## Town of Reading

Re: Sign Package & Photometric Plan - McDonald's 413 Main St, Reading, MA

**To:** Andrew MacNichol, Community Development Director  
**From:** Ryan A. Percival, P.E., Town Engineer;  
**CC:** Community Planning and Development Commission;  
**Date:** August 31, 2023  
**Re:** Proposed Site Re-development 413 Main Street - McDonald's

**LIGHTING NOTES**

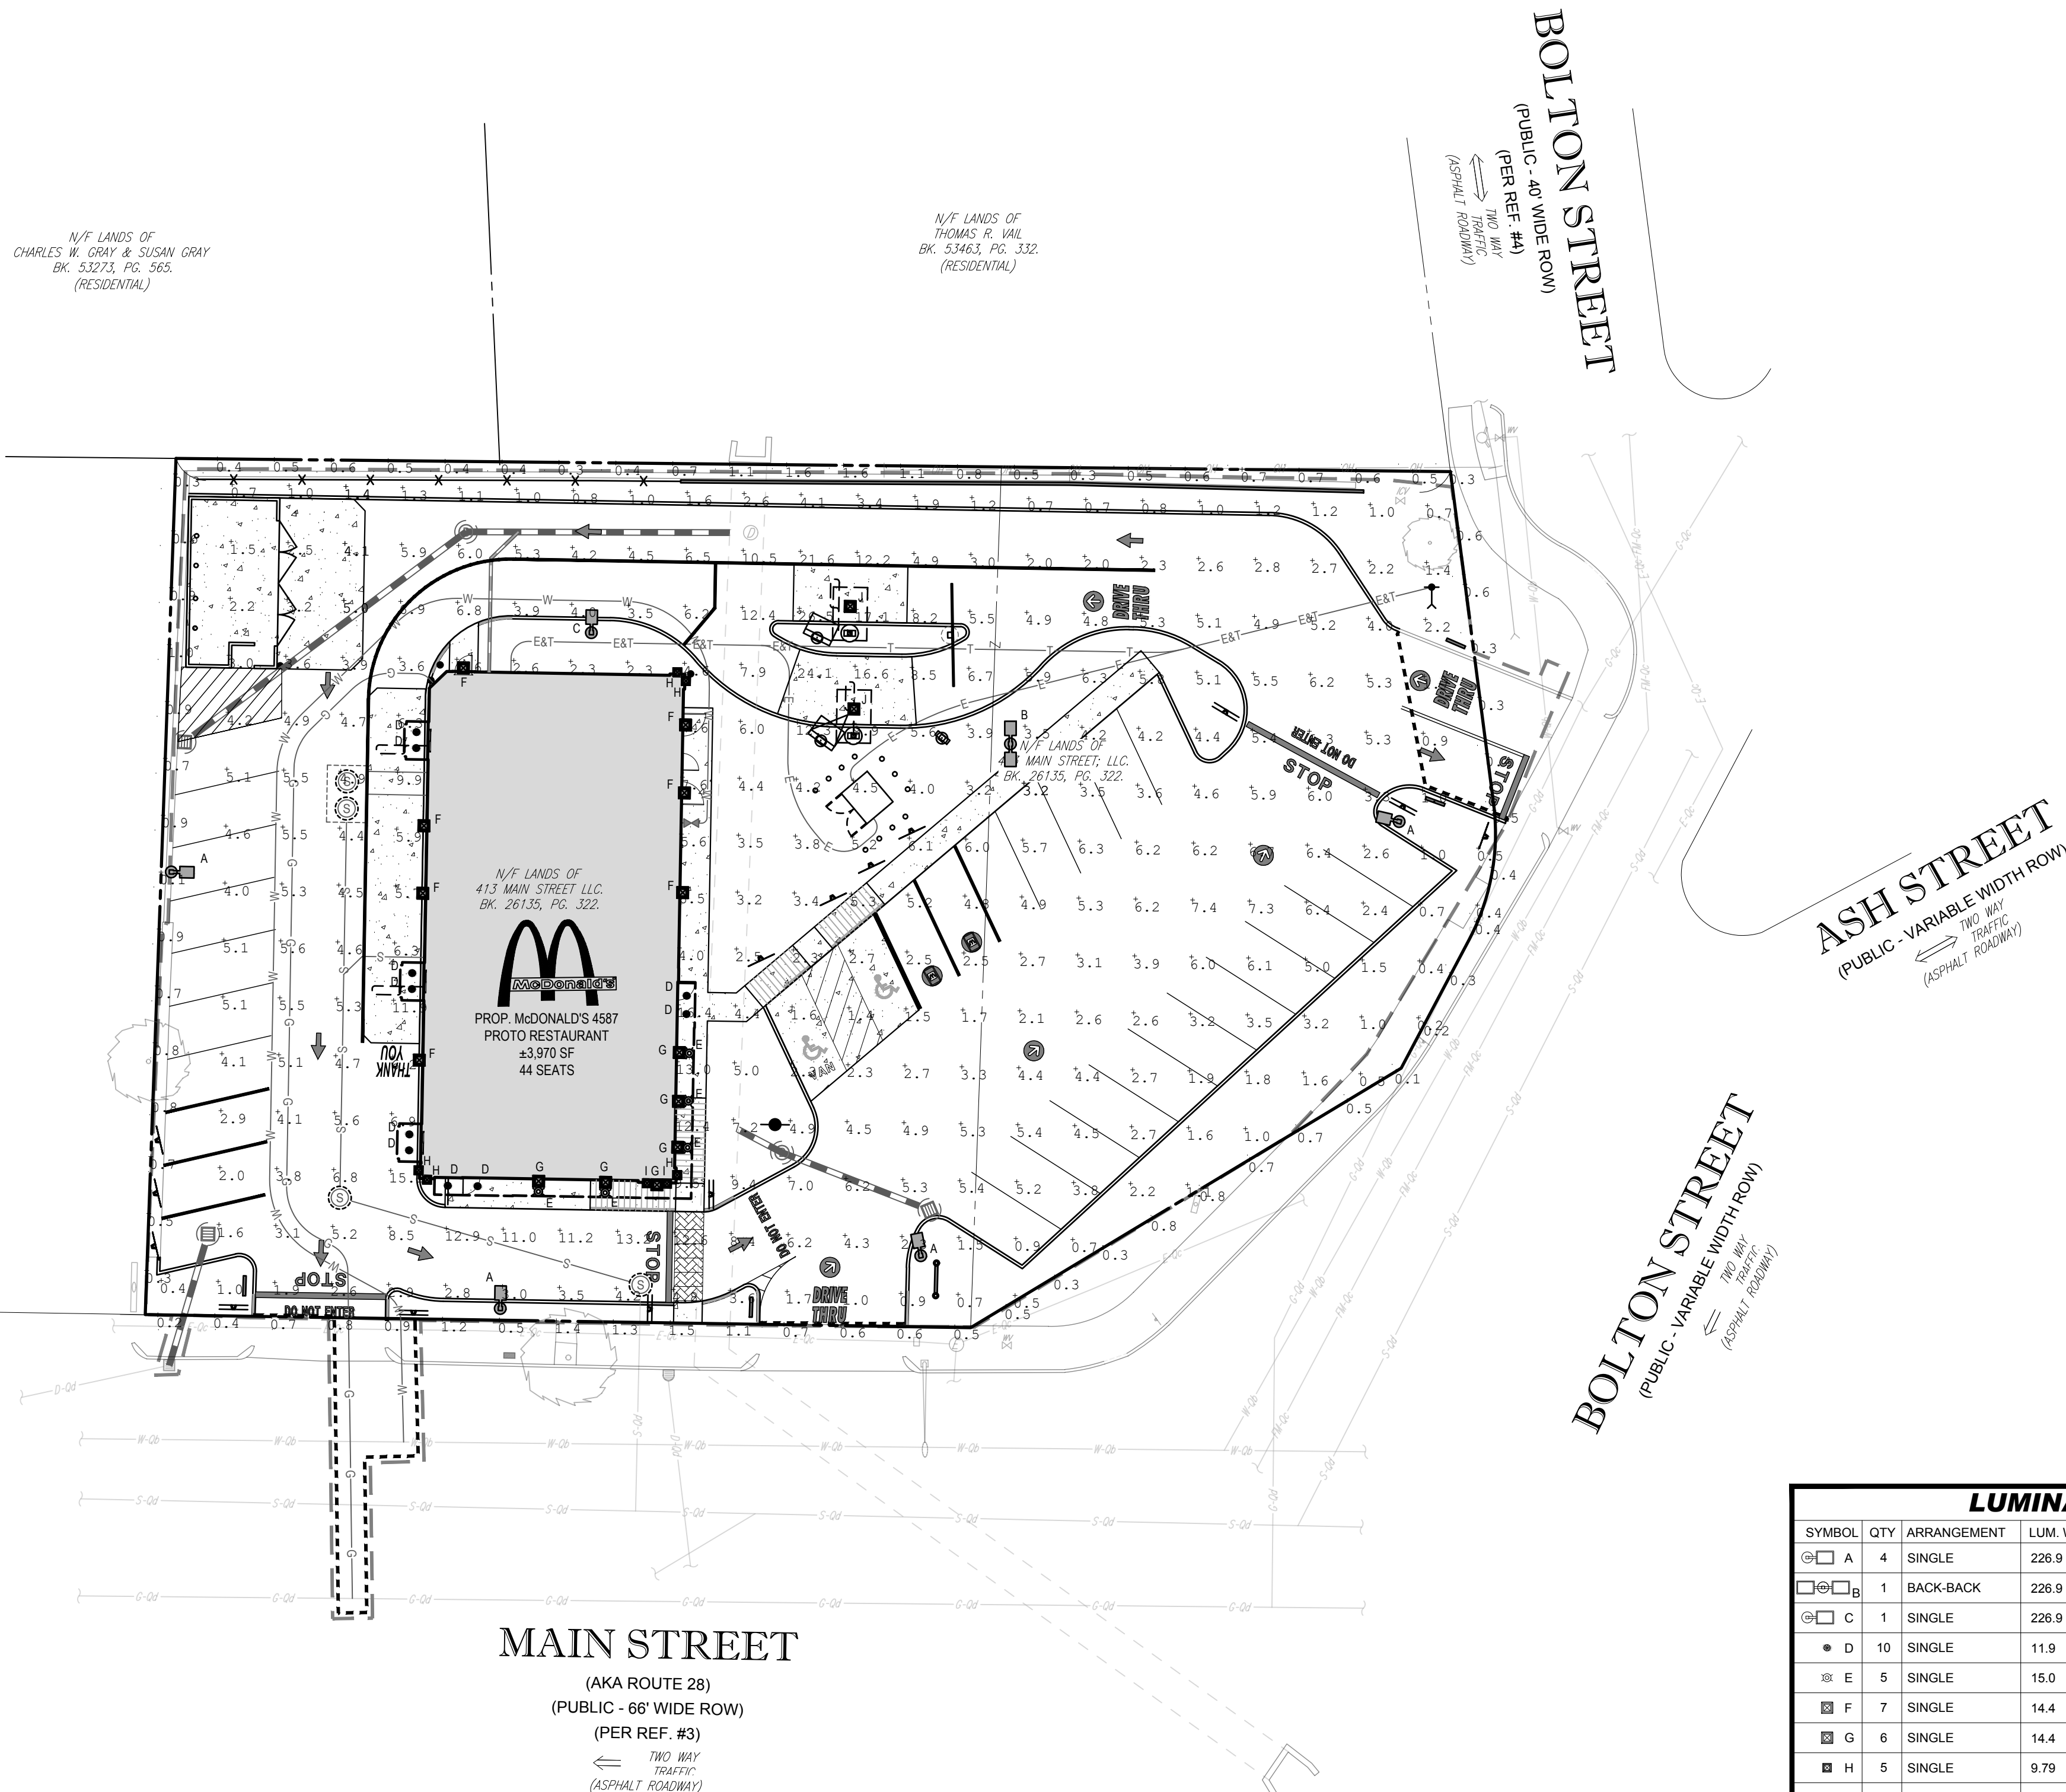
Additionally, several of the items included in the sign package appear to be lights, but do not appear to have been included in the photometric lighting plan. The sign package plans are cut off on the top, there are a number of arrows with no labels and as such it's also unclear if there are additional lights proposed on the top of the building. Please ascertain that all lights, including any on the building and order points are included in the photometric plan.

**Response 6:** The lighting plan has been updated to include building lighting and the photometric information over the landscaped areas of the site. Please refer to Sheet C-703 of the "Proposed Site Plan Documents" for additional information.

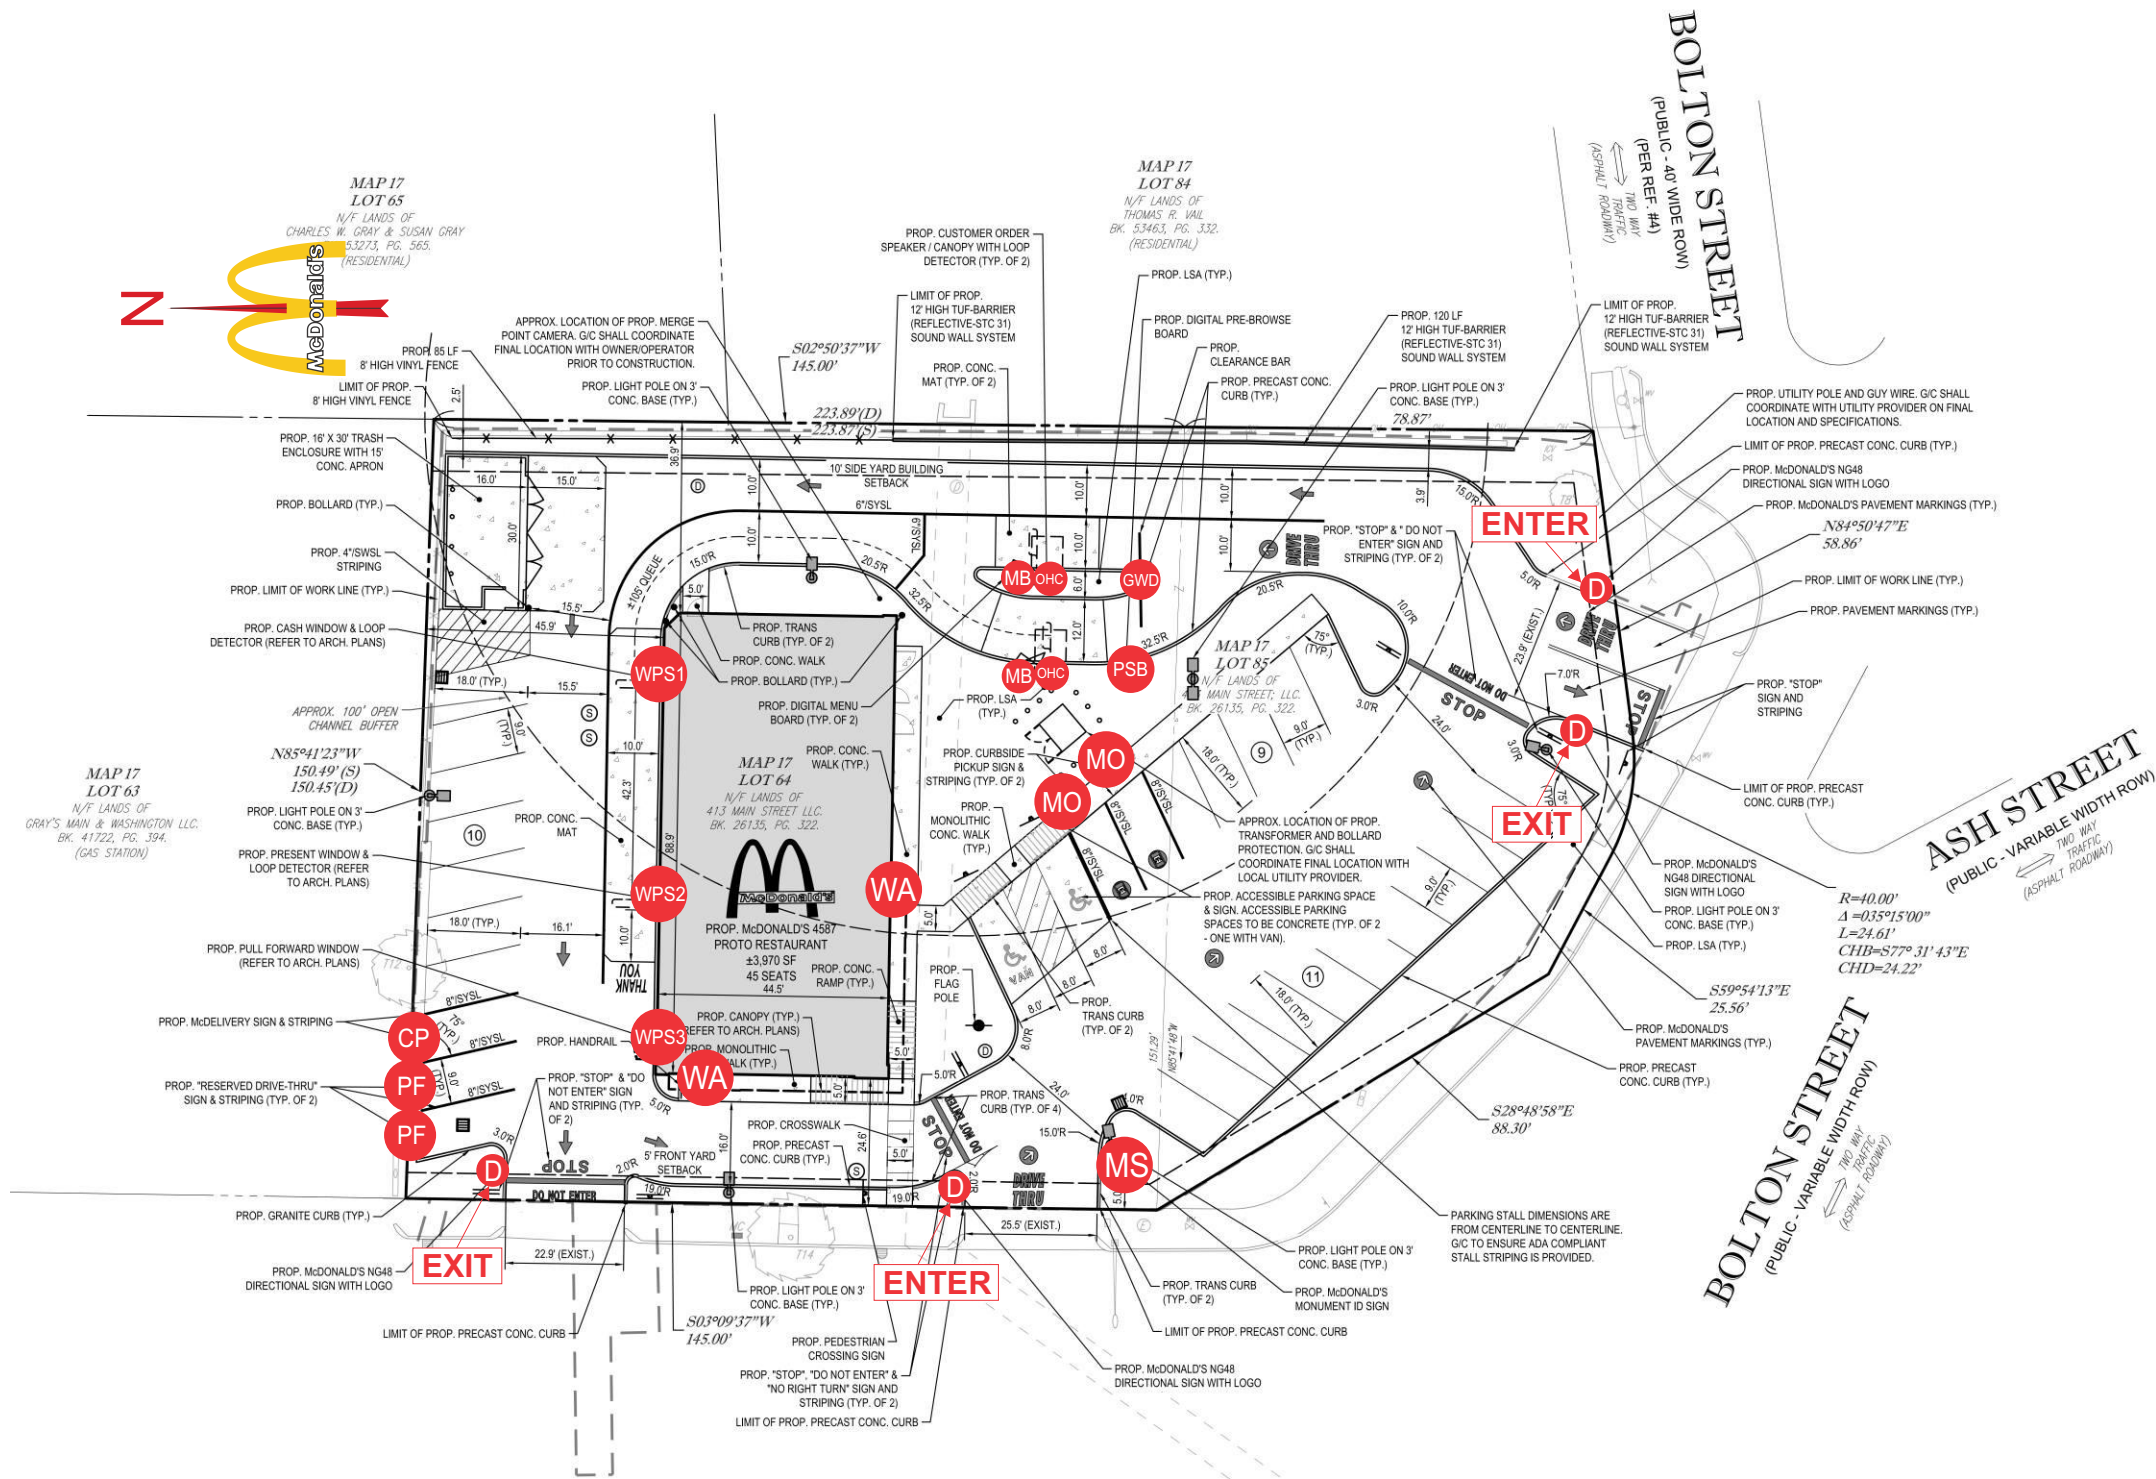
Regarding the plans submitted, the sign package plan sheet 2 indicating which signs would be where on the property doesn't specify which size digital menu boards will be placed where. Please clarify on this plan sheet.
